# UDPRP Review Summary

Urban Design Peer Review Panel

DATE: 4.28.23

**PROJECT: MLK Medical Office Building**

**PROPOSED SITE IMPROVEMENTS**

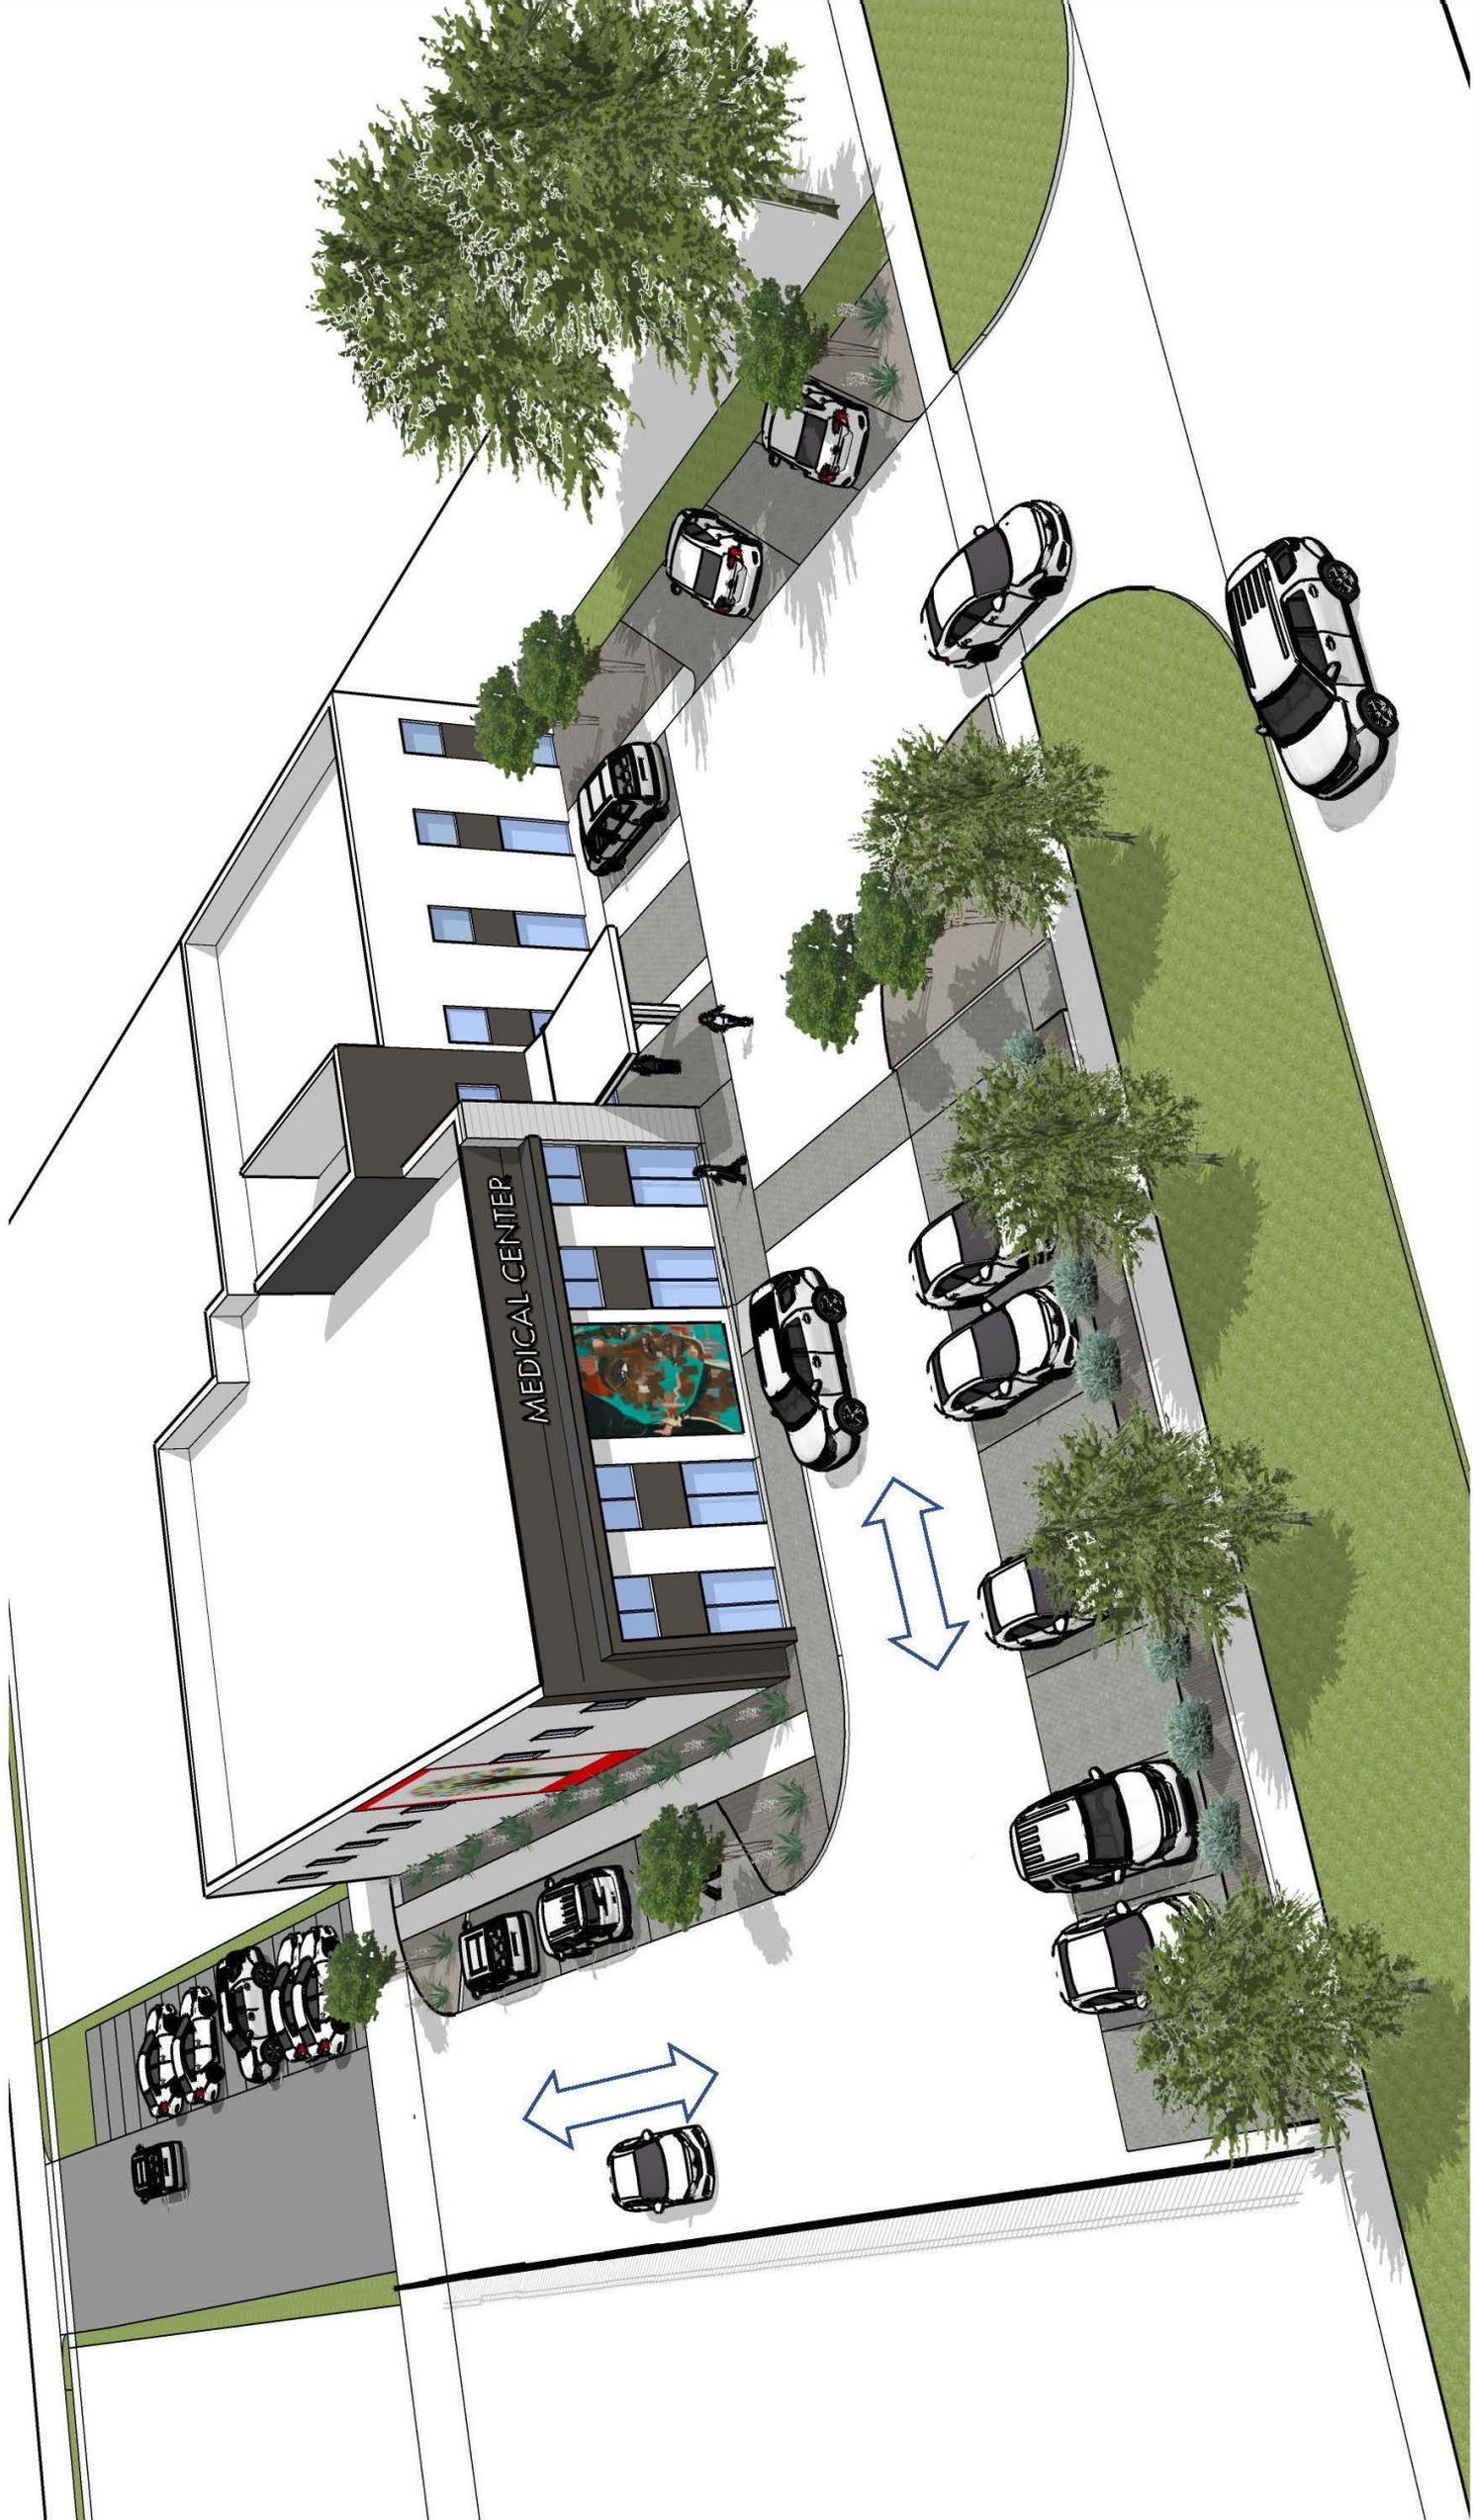
1. The Panel recommends the applicant explore opportunities to reduce the amount of land given up to parking to set the standard for future MLK improvements and help encourage the idea of walking by looking into shared parking opportunities. Consider eliminating or reconfiguring two of the three existing driveway curb-cuts on MLK, creating a shift in parking, and opening opportunities for additional parking elsewhere.

2. The Panel suggests exploring strategies to push sustainability opportunities on the site including permeable paving at the front of the site, as well as designing for water collection and water consumption.

3. The Panel advises exploring the opportunity to maintain the mural in its current location or the reconfiguration, relocation, or reinterpretation of the mural.

4. The Panel recommends similar treatment be given to Peabody Avenue as are being proposed along MLK with respect to landscaping.
5. The Panel advises the parking and dumpster configuration in the rear alley be considered to facilitate its use and meet code requirements.

6. The Panel recommends scrutiny be given to secure pedestrian accessibility from MLK and parking lots to the facility's main entry.
7. The Panel recommends sensitivity be given to site lighting and its impact on neighbors.

8. The Panel advises parking on the side closest to Peabody not encroach past neighbor's front yard.
